**LIBRARY & ADMIN RENOVATIONS  
ST. PAUL'S CES, PETERBOROUGH  
FOR PVN&CCDSB**

**ADDENDUM NO. 1**

## **ADDENDUM #M1**

**ELECTRICAL ADDENDUM #1**

DWG  
**SK-E1**

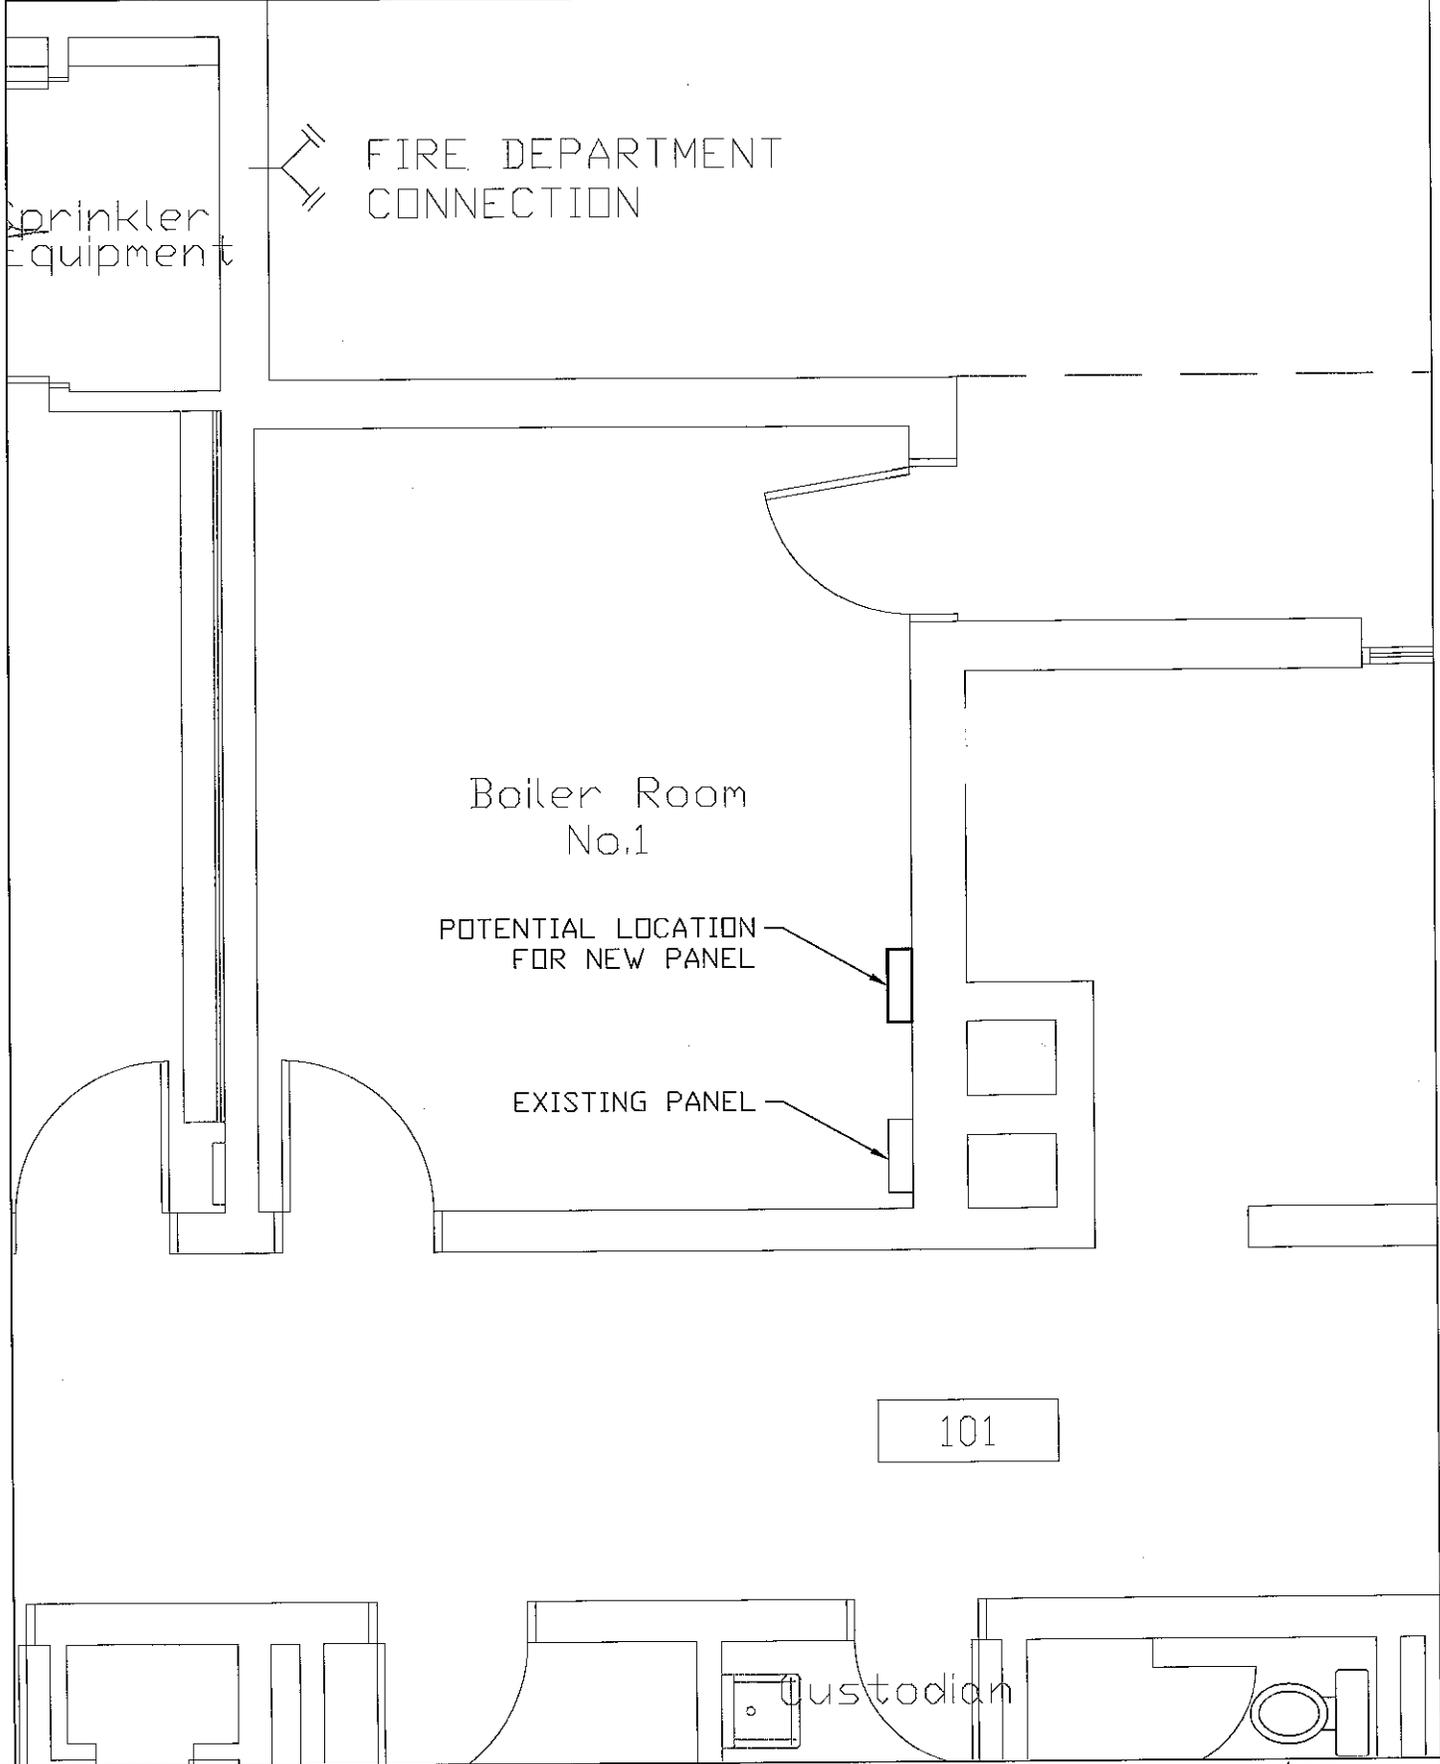
1. Supply and install a 200A, 120/240V breaker in existing Panel, located in the Boiler Room.
2. Supply and install new 200A panel in Boiler Room.
3. Contractor to relocate some miscellaneous equipment to allow for space for the new panel. Contractor shall visit site to determine what needs to be relocated, and to where it can be relocated.
4. The new panel shall feed the power circuits listed in Panel 'B' on drawing E1.
5. There is one 3-phase load remaining on Panel 'B' for DH-4A. Contractor to locate a power source for this 3-phase load.
6. See Sketch SK-E1 for approximate location of existing and new panels.
